What we asked

WESTERLY INTERIOR SIDE YARD SETBACK

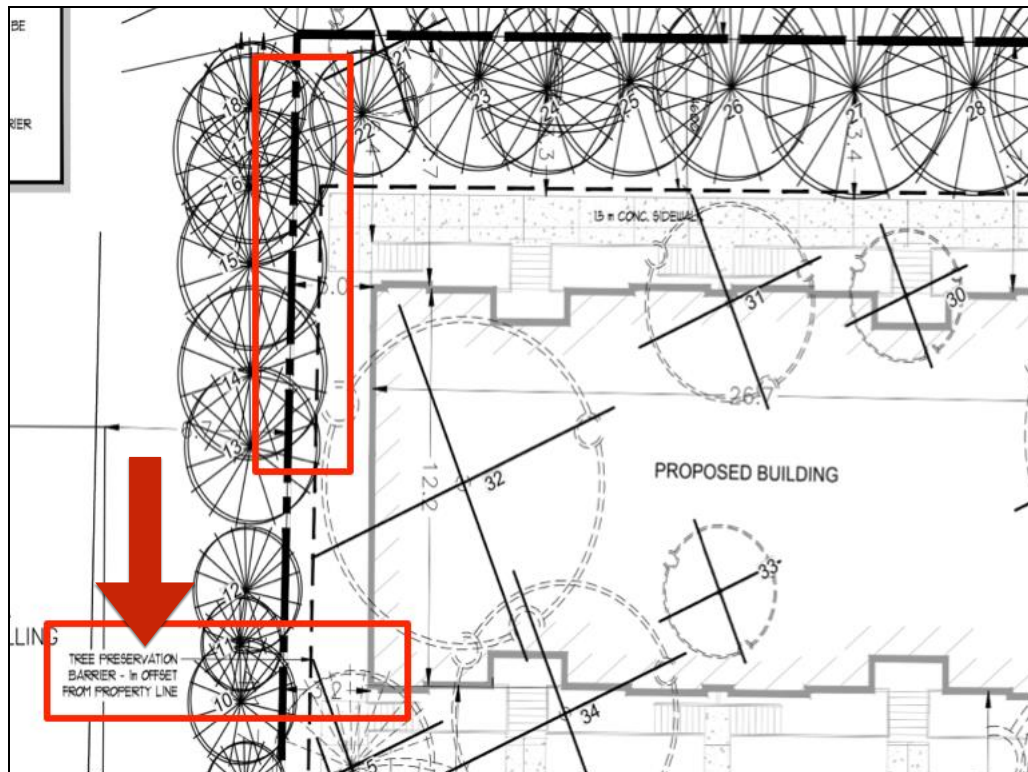
There are several inaccuracies within the tree report and tree plan that are key to staff recommendations regarding the side yard setback

- when side yard setbacks were 1.7m, the original tree plan set the tree protection zone - indicated by the dashed line, at 0.5m from the west property line.
- The tree protection zone is supposed to establish the necessary distance required to protect the trees
- Notice how the canopy for the larger trees extend beyond this zone.
- these trees are on the neighbouring property and are not supposed to be impacted by this development.

- With side yard setbacks now at 3m, the latest tree plan sets the tree protection zone at 1m
- Which is correct and why is it changing?

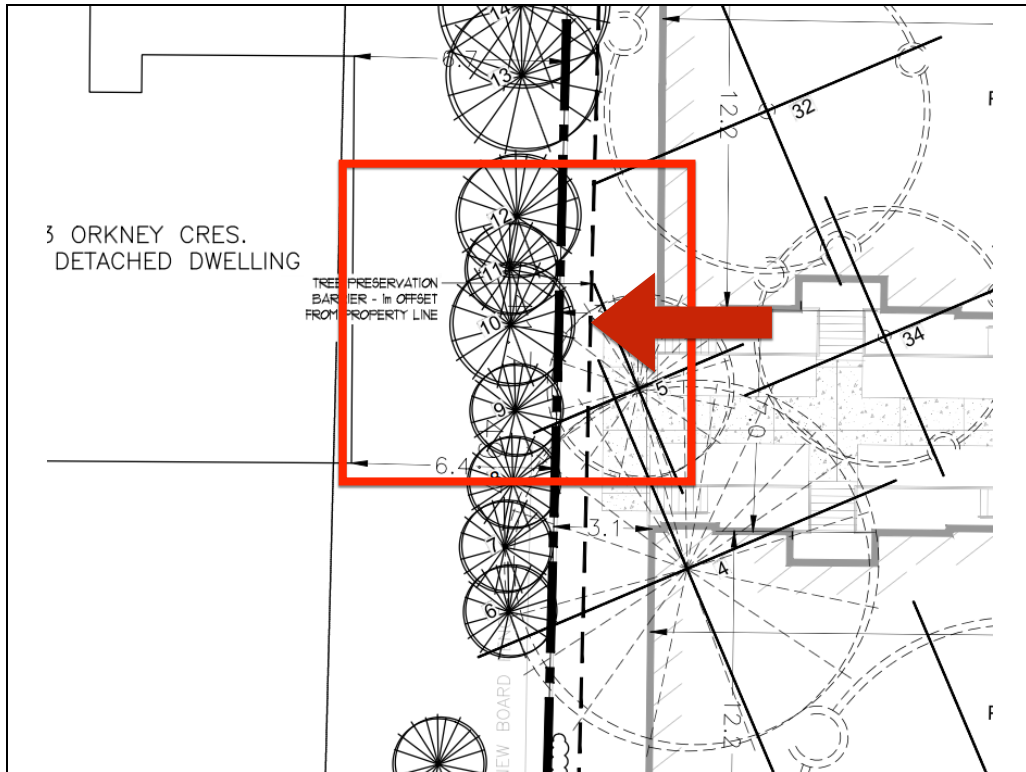
1. The canopy measurements represent the drip line of the trees. Several of the canopy measurements are **incorrect**, in some cases by greater than 1m

- The drip line for tree #10 is shown as 2m, which is smaller than several other trees, even though the diameter is the largest in this section at 30cm.

- It appears the drip line measurement for tree #10 was taken based on the canopy on the east side of the tree, which is sparse

- rather than the west side which is much larger, measuring 3.3m even AFTER PRUNING BY THE OWNER

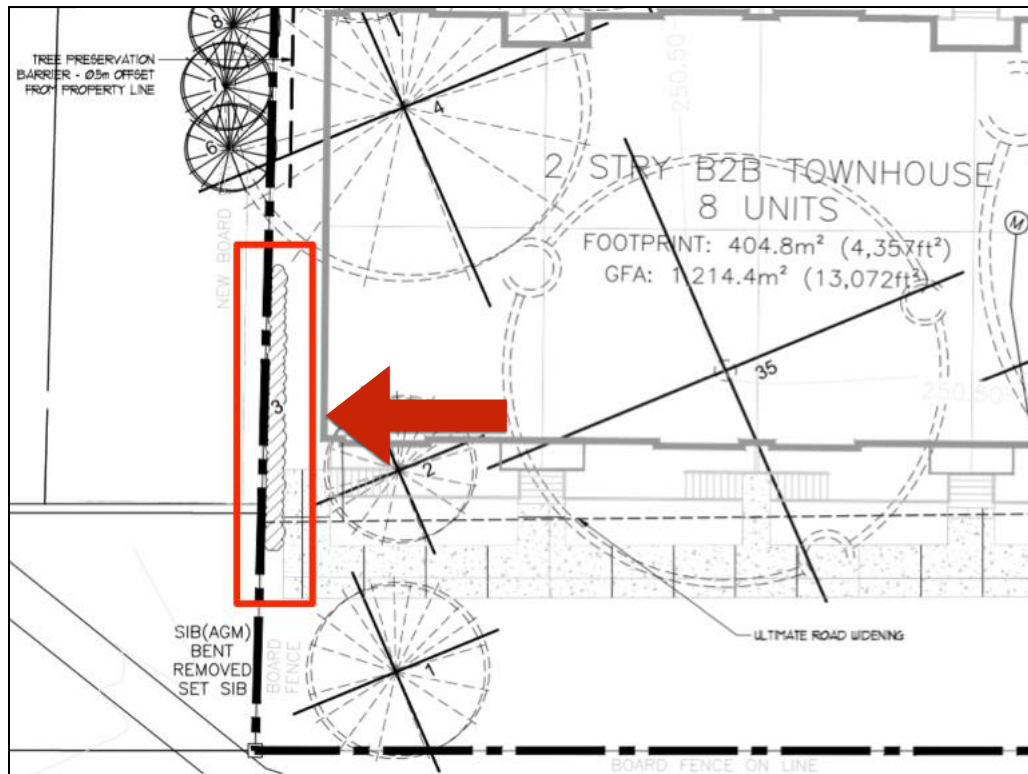
- For tree #10, with a diameter of 34cm, based on up to date measurements, the critical root zone shall be 4.8m

- red circle represents the more recent measurement of tree #10's canopy.
- blue circle represents the DBH method which is recommended in this case
- notice the proximity of the critical root zone to the proposed building at a 3m setback
- notice also the critical root zone for tree #17 near the top and how it extends well past the tree protection zone

Slide 18

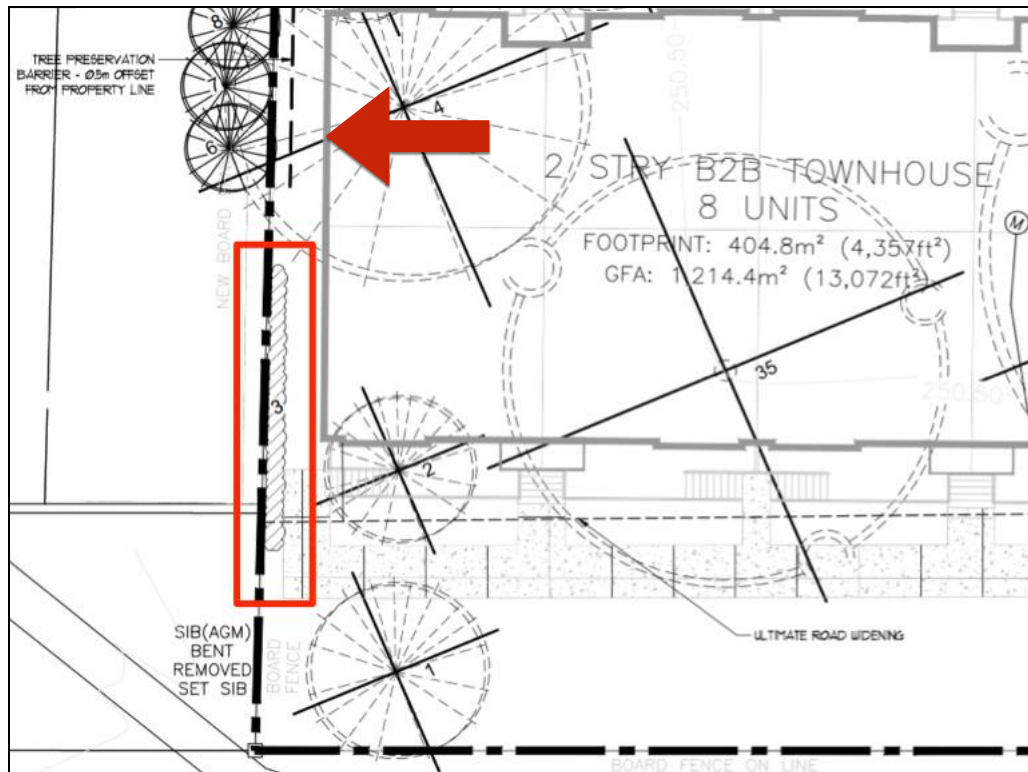
- this is highlighting cedar hedge #3 from the tree plan.

- which is in fact a row of trees

- these trees are located on 123 Orkney Cres property, NOT 536 Windermere as shown on the tree plan

- these trees do not appear to be considered when establishing the tree protection zone, as you can see from where the dashed line ends.

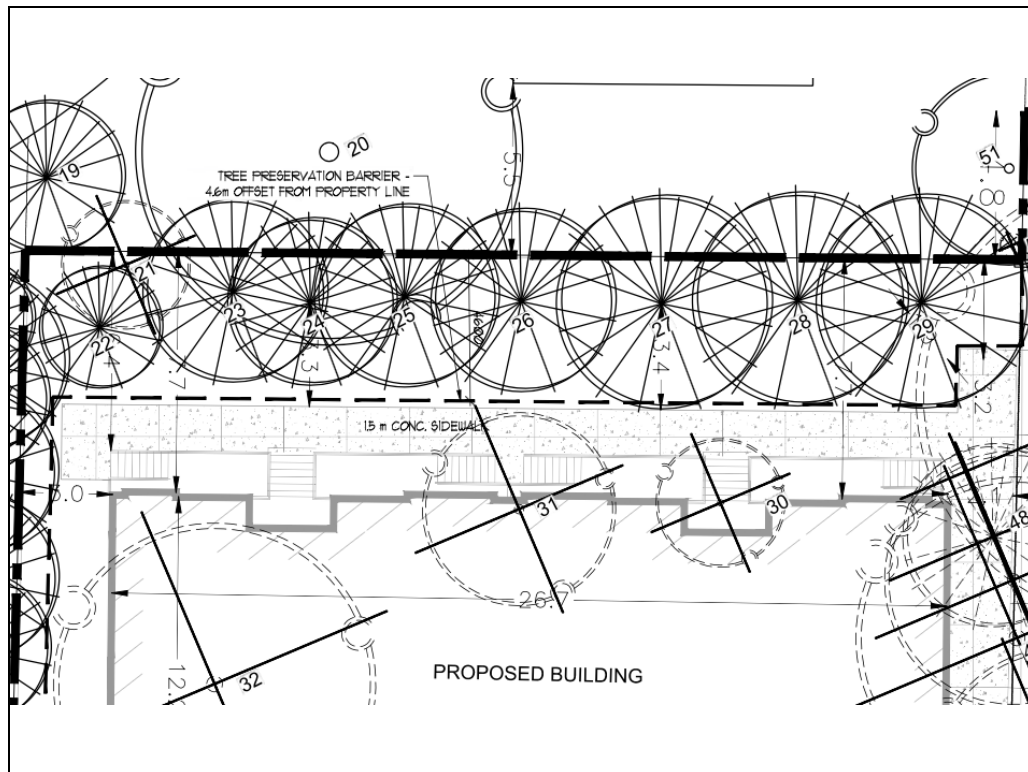
- One of these trees has a diameter of 14cm, and a critical root zone of 3.6m.
- which extends beyond the 3m side yard setback recommended.

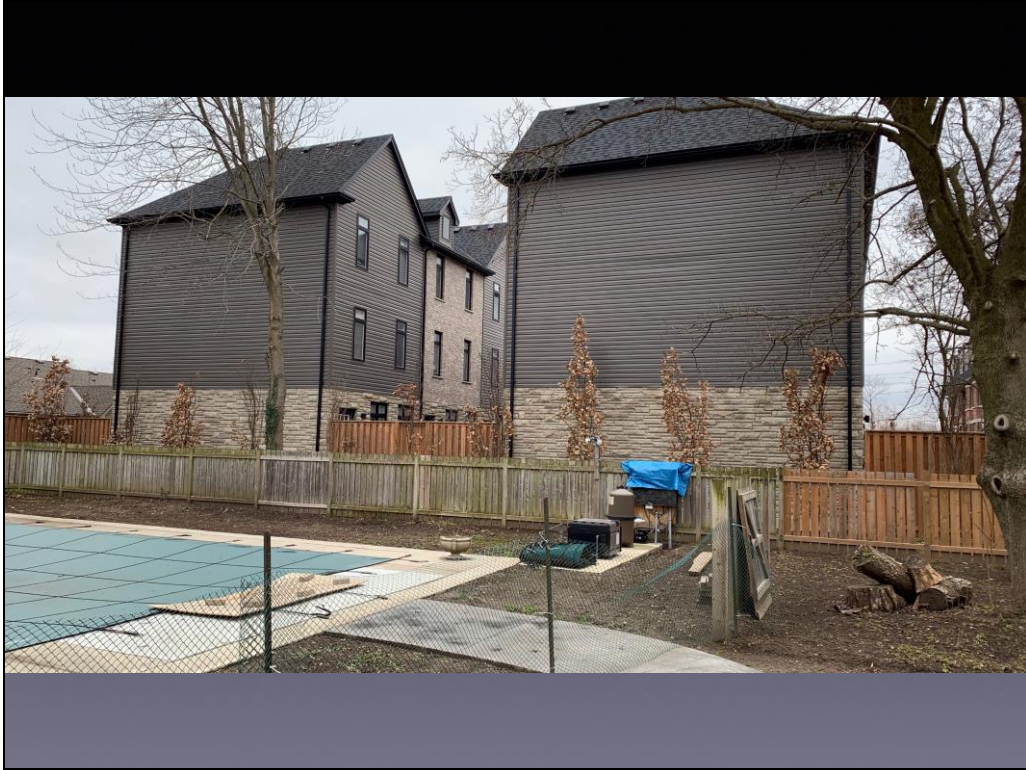
- A similar situation regarding inaccurate canopy measurements also occurs with regards to the trees along the northern property line
- some measures are off by more than 1m
- calling in to question the tree protection zone on this side as well.
- If we don't get this right, these trees, and the screening they provide may be lost
